CERTIFICATE OF APPROPRIATENESS

Property: 1141 Arlington, lot 1, block 198, Houston Heights Subdivision. The property includes a historic 1,376 square foot, one-story wood frame single-family residence situated on a 6,600 square foot (66' x 100') corner lot.

Proposal: Alteration – Enclose a 12' deep by 11'-1" wide by 13'-5" tall portion of an existing rear screened-in porch.

Basis for Issuance: HAHC Approval
Effective: December 17, 2014

SOUTH SIDE ELEVATION

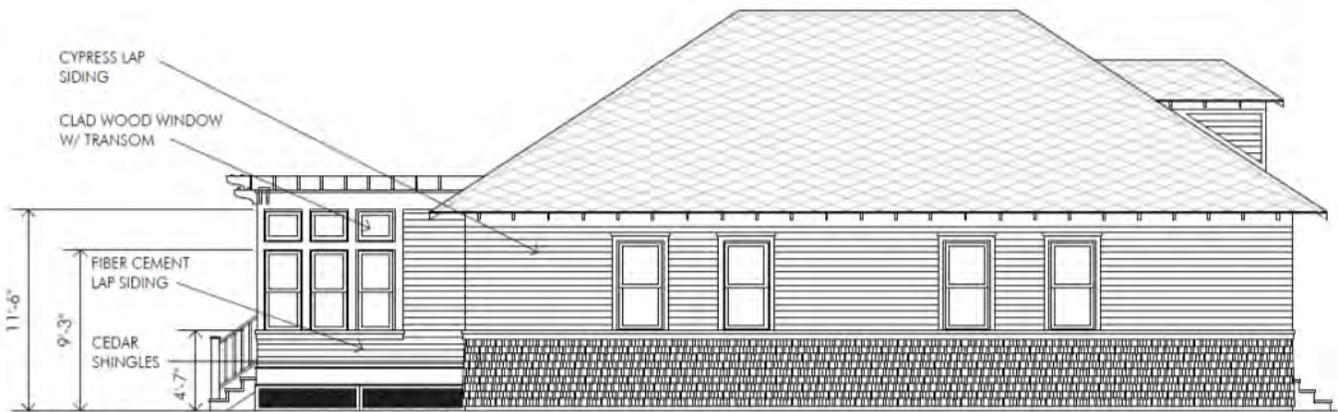
Side Elevation: This elevation will be clad in fiber cement siding and contain three 1-over-1 windows with transoms above.
(South)

The revised submission that includes 1 over 1 windows and transoms is compatible with existing historic elements of contributing structures in the district.

WEST (REAR) ELEVATION

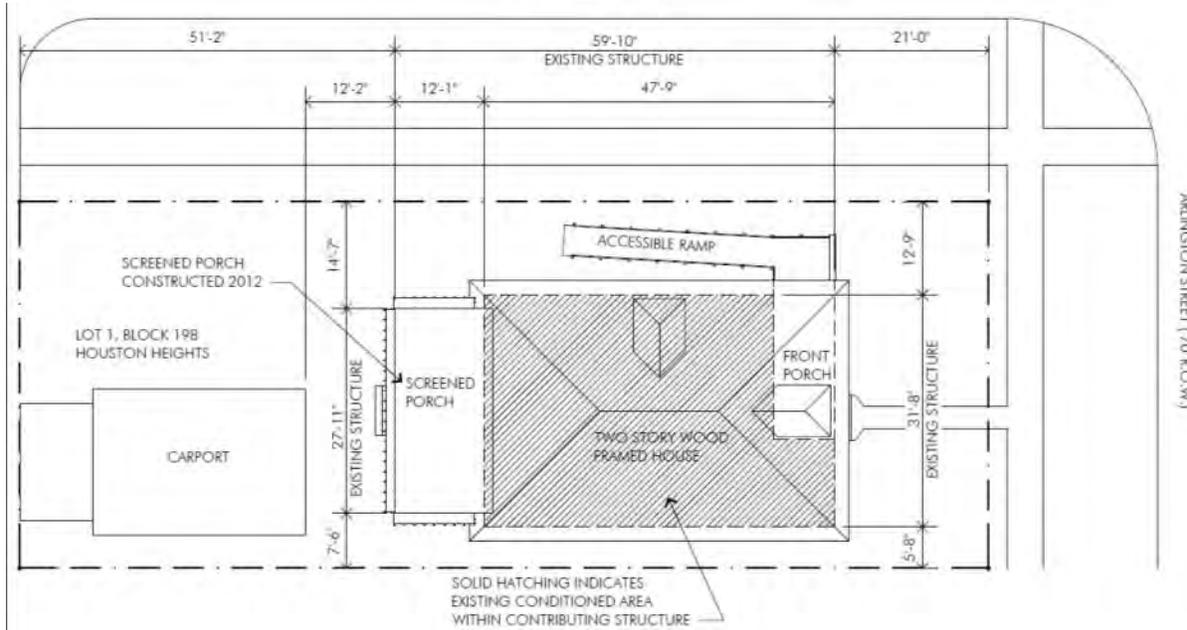
Rear Elevation: This elevation will contain four new 1-over-1 windows with transoms above. The existing screen panels and screen door will remain.
(West)
